UNITED STATES PATENT AND TRADEMARK OFFICE

APPLICATION NO.	FILING DATE	FIRST NAMED INVENTOR	ATTORNEY DOCKET NO.	CONFIRMATION NO.
10/757,919	01/15/2004	David Michael Toth	71,024-003	5120
27305	7590	02/14/2006	EXAMINER	
HOWARD & HOWARD ATTORNEYS, P.C. THE PINEHURST OFFICE CENTER, SUITE #101 39400 WOODWARD AVENUE BLOOMFIELD HILLS, MI 48304-5151				MITCHELL, KATHERINE W
			ART UNIT	PAPER NUMBER
			3677

Office Action Summary	Application No.	Applicant(s)
	10/757,919	TOTH ET AL.
	Examiner	Art Unit
	Katherine W. Mitchell	3677

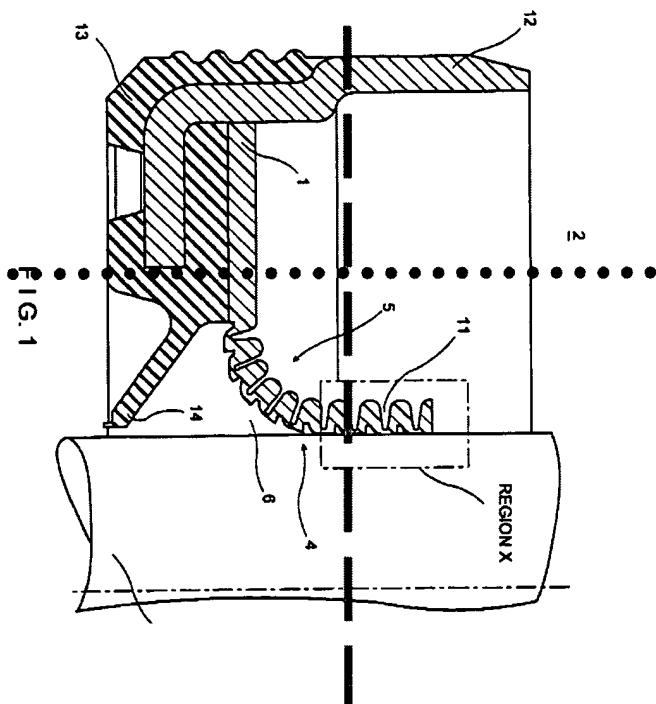
Re claims 1, 4, 13: Guth teaches a seal assembly (Fig 1) comprising

- A rigid carrier 12
- An annular support member 14 engaged with carrier having a lip (see Fig 1, lip is portion extending past 12, past examiner's dotted line) defining an annular supporting surface, described as a dynamically stressed ballast gasket surrounding shaft under elastic radial prestress, attached by vulcanization to carrier 12 in col 3 lines 12-17.

- A PTFE (col 3 line 18-20) seal 1,5,11 having a 1st collar (to left of dashed line - see dashed line by examiner showing end of 1st collar portion and beginning of 2nd collar portion in Figure 1 below) connected to said supporting surface and a 2nd collar portion extending past said supporting surface and defining a 2nd sealing surface (to the right of examiner's dashed line below). The 1st collar and 2nd collar portion in Figure 1 below have sealing portions that simultaneously engage the rotating surface to establish a dynamic seal therebetween. Only the 1st sealing portion, defined on 1st collar, remains backed and reinforced by said flexible annular support member.

Further Re claim 13: The 1st collar portion is connected directly to the annular support surface, and the 2nd collar freely extends from the first collar portion, and there is an annular living hinge disposed between the 2 - the living hinge is any of the u-shaped recesses such as at "11".

Further Re claims 1,4, and 13: However, Guth is not specific on the material of the annular support member, Guth describes it as a dynamically stressed ballast gasket surrounding shaft under elastic radial prestress, attached by vulcanization to carrier 12 in col 3 lines 12-17. It would have been considered obvious to one of ordinary skill in the art, at the time the invention was made, to have selected rubber or polymeric materials, since it has been held to be within the general skill of a worker in the art to select a known material on the basis of its suitability for the intended use as a matter of obvious design choice. In re Leshin, 125 USPQ 416. It would have been obvious to

make the gasket 14 of polymer as polymers are well-known in the gasket and seal art, and can be selected to provide wear and chemical resistance, and are widely available and inexpensive or of rubber, as rubber is also well known in the art and provides various hardnesses, resistances, depending on the rubber selected, and is very widely distributed and inexpensive.

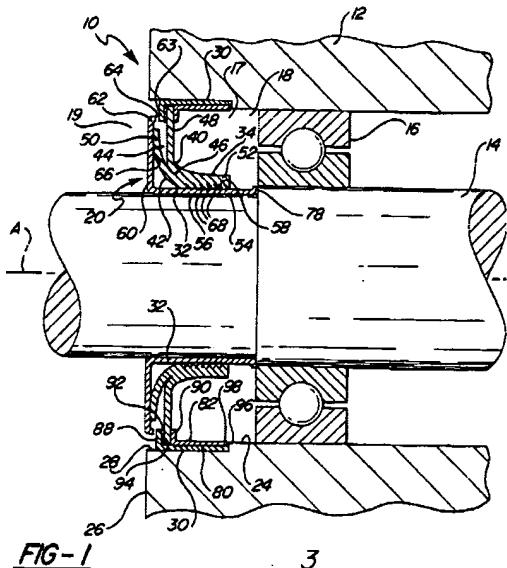
Guth teaches a seal assembly (Fig 1) comprising

- A carrier 12 having tubular portion (section shown in Fig 1 and a radial flange portion extending therefrom).
- An annular support member 14 engaged with carrier having a lip (see Fig 1, lip is portion extending past 12, past examiner's dotted line) defining an

annular supporting surface, described as a dynamically stressed ballast gasket surrounding shaft under elastic radial prestress, attached by vulcanization to carrier 12 in col 3 lines 12-17.

- A PTFE (col 3 line 18-20) seal 1,5,11 having a 1st collar (to left of dashed line - see dashed line by examiner showing end of 1st collar portion and beginning of 2nd collar portion in Figure 1 below) connected to said supporting surface and a 2nd collar portion extending past said supporting surface and defining a 2nd sealing surface (to the right of examiner's dashed line below). The 1st collar and 2nd collar portion in Figure 1 below have sealing portions that simultaneously engage the rotating surface to establish a dynamic seal therebetween. Only the 1st sealing portion, defined on 1st collar, remains backed and reinforced by said flexible annular support member.

Further Re claims 12,10: Wear sleeves are well known in the rotating shaft seal art, as evidenced by Tripathy. A wear sleeve 232 is shown in Tripathy Fig 5. Col 3 lines 29-67 describe the relationships of the wear sleeve with a rotatable shaft. It also teaches a carrier 230, which is also shown as tubular (it would inherently encircle the shaft, thus tubular) and concentric w.r.t. the wear sleeve, and also has a radial flange (portion labeled 288 to 264), per col 4 lines 18-37 (describing Fig 4 but corresponding numbers are used in Fig 5 but with "200" prefix - i.e., "63" is "263" in Fig 5, etc.). Note that the "shaft" of the wear sleeve is concentric about the shaft, and thus a shaft with a wear sleeve will have the seal contact the wear sleeve rather than the shaft, since that is the section that will wear. Therefore, it would have been obvious to one of ordinary skill in the art at the time the invention was made to provide a wear sleeve, as wear sleeves are well known and used as "sacrificial" surfaces to be replaced rather than replacing a shaft, and they are commonly provided with annular outwardly facing sealing surfaces to provide an additional seal to help seal out dust, etc and protect the seal.

Re claim 11: there is an annular living hinge disposed between the 2 collar portions as shown in Guth Fig 1- the living hinge is any of the u-shaped recesses such as at "11". The u-shaped coutout is considered a notch.
